**ISSUE:** Permit to Demolish/Capsulate (partial) and Certificate of Appropriateness for alterations and Waiver of Rooftop HVAC Screening Requirement

**LOCATION:** Old and Historic Alexandria District  
413 North Washington Street

**BAR #2021-00236 & BAR #2021-00261**  
**413 North Washington Street**

**Figure 3: Proposed elevation of east wall**

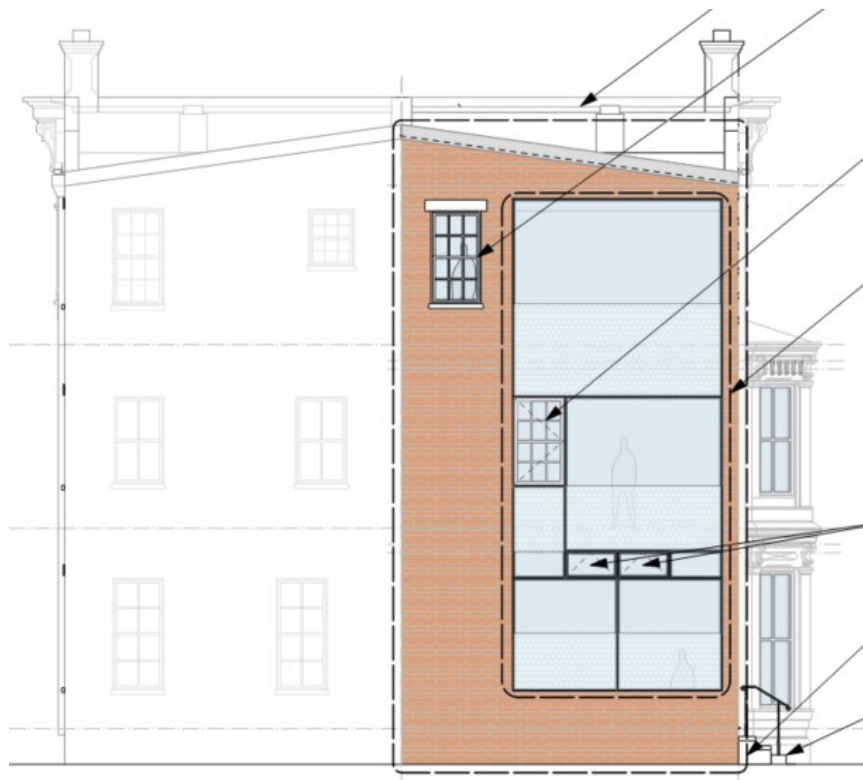
Upon deconstruction of the existing wall, any brick that can be salvaged will be used to reconstruct the portion of the wall to the south of the new window opening. While the rear wall will contain some historic brick, it is essentially a blank canvas, and the use of modern fenestration helps to differentiate this part of the house from the largely untouched side and front elevations. While this elevation is not an addition, it is consistent with the *Design Guidelines* recommendation that “An addition to a historic building should be clearly distinguishable from the original structure. An addition should not obscure or dilute the architectural and historic importance of an existing building by creating a false sense of the past.”

The east side of the building will be minimally visible from a public right of way. The parking lot to the east of the building is private property, meaning that the only visibility will be oblique views from Oronoco St, St Asaph, and Princess Streets (Figure 4). Due to the minimal visibility and structural need to rebuild the existing wall, staff supports the proposed modification and recommends that the applicant work with staff to ensure that the storefront system meets the *New and Replacement Window Performance Specifications*.

**Figure 5: Proposed roof plan showing sunken roof deck at the west end of the roof**

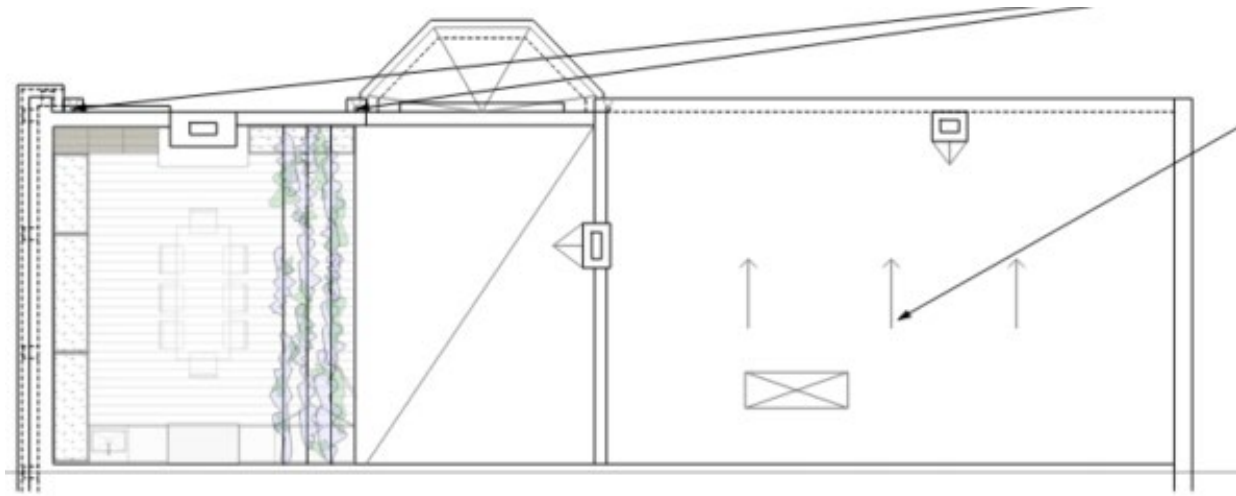
The proposed modifications to the building to create the new roof deck do not have a direct influence on the appearance of the building with the exception of how the third floor will be perceived from North Washington Street. This is an important view and staff has expressed to the applicant that the presence of a roof deck in this area should not be evident from the public right of way. This proposal is a unique approach to the introduction of a roof deck into a historic structure and resolves some of the concerns typically associated with the construction of a roof deck. Because the deck is at the level of the third floor, there is no need to extend stairs or an elevator above the existing roof line. The proposed roof deck does not alter the roof line in any way, preserving the historic building form.

While staff finds this approach to be potentially successful, there are a number of concerns that are raised associated with the protection of the existing structure. While these may not be directly visible from the public right of way, the protection of historic buildings is a foremost mission of staff and the BAR. The submitted documents include only schematic plans of the area and some views from Washington Street but they do not include details on how the structure is to be protected from exposure to the elements. Some issues to be addressed by the applicant relative to this proposed work include the following:

- The historic windows will remain in place and will now be exposed to the elements on both sides. How will these windows and the masonry opening at the jambs and sills be protected from water infiltration?
- How can these windows be treated so as not to alter the view of the building from North Washington Street?
- As noted above, the removal of the roof framing will require the introduction of lateral supports for the existing masonry walls. How will this be accomplished without damaging the walls?

- The interior finish of the existing walls will need to be removed to create a surface that can be exposed to the exterior, how will these walls which are now exterior on both sides be protected?
- Will the removal of the roof cause a negative impact on the decorative cornice at the top of the west elevation?
- Will there be an impact on the existing third floor framing due to the introduction of rainwater and roof loads not previously envisioned?

While many of these are technical issues, they directly impact the historic fabric of the building and how it is viewed from North Washington Street. Staff recommends that the portion of work associated with the creation of the roof deck on the third floor be deferred to allow for further study and clarification as to how the historic fabric will be maintained and protected.

Staff recommends that the BAR defer approval of the Permit to Demolish/Capsulate (partial) and Certificate of Appropriateness for alterations associated with the proposed recessed roof deck in order for the applicant to address questions and comments from staff and the Board.

**North Elevation**  
Scale: 1/8" = 1'-0"

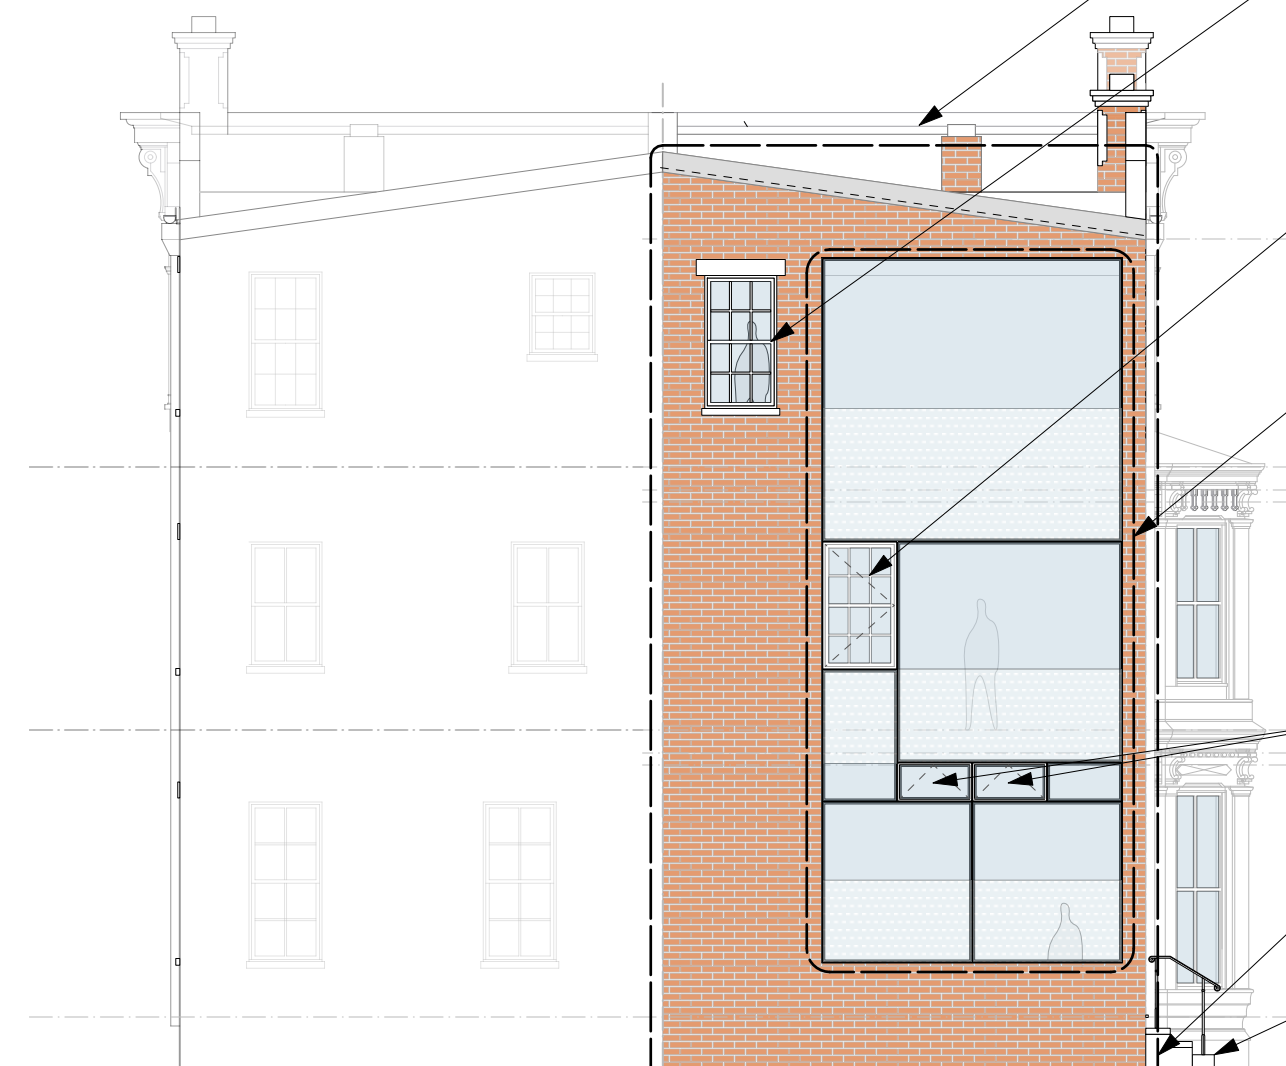
Per the submitted documents, the applicant is proposing to replace the existing windows on the second and third floor, east of the existing two-story bay window. New windows are proposed on the second and third floors, the windows being proposed are to be 6-over-6 wood double glazed windows with simulated divided lites in the original openings. Staff and the applicant walked through the interior of the house to inspect each window on the north elevation and the majority are either original or very old, and most have cylinder glass. One aspect that staff was particularly interested in understanding as part of the site visit was why the first and third floor had six-over-six windows and the second floor had two-over-two windows (Figure 2). Staff has determined that it is likely that the two-over-two windows are very early replacement windows and that these windows were all probably six-over-six, which is the case with the twin townhouse at 411 North Washington Street. This is not unusual as builders typically used the most modern and most expensive materials on the fronts of buildings, or in this case, the side of the building up to and including the projecting bay.

Per the Board's policy and general preservation philosophy, staff does not support the replacement of historic wood windows that can be retained and repaired. However, since the two-over-two windows were early replacement windows, staff does not object to the replacement of the second-floor windows with wood six-over-six windows, provided that the applicant preserve the glass in the windows to be removed to replace the various pieces of broken glass in the historic six-over-six windows. In summary, staff finds the following with respect to the proposed new windows on the north elevation:

The applicant is proposing to rebuild the two existing exterior brick steps at the north side of the building and install simple handrails at each location. While staff has no objection to the replacement stoop or the historically appropriate metal railing, this portion of the site is not located on the applicant's property, but rather is part of the 415-417 North Washington Street property. The building permit documentation must include proof that the neighboring property owner will permit these features to encroach.

- The windows on the second floor (two-over-two) may be replaced with new six-over-six wood windows
- All historic windows on the third floor must be retained and repaired
- Glass from the two-over-two windows should be retained and used to replace broken glass in the windows which will be retained

Photo 5:

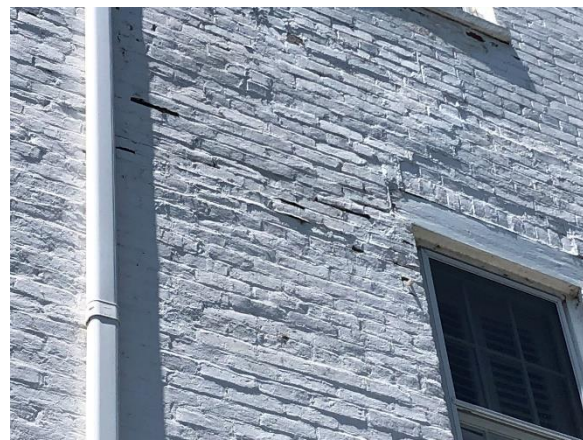
Photo 5 show both the deterioration of the masonry and its outward displacement at the second floor level.

The structural conditions noted above warrant significant structural repair and stabilization as part of the upcoming renovation and preservation work. Of particular concern is the outward bowing of the façade, which needs to be minimally addressed with more robust connection to the floor and roof diaphragms. Also very significant, but less easily quantified, is the apparent deterioration of the mortar and masonry units that has resulted from a long history of moisture infiltration and entrapment. The combined effects of these structural conditions and the history of modification (window infills, lintel replacements) makes a more substantial rebuilding much more appropriate and offers an opportunity to restore physical integrity to this essential component to the building structure.
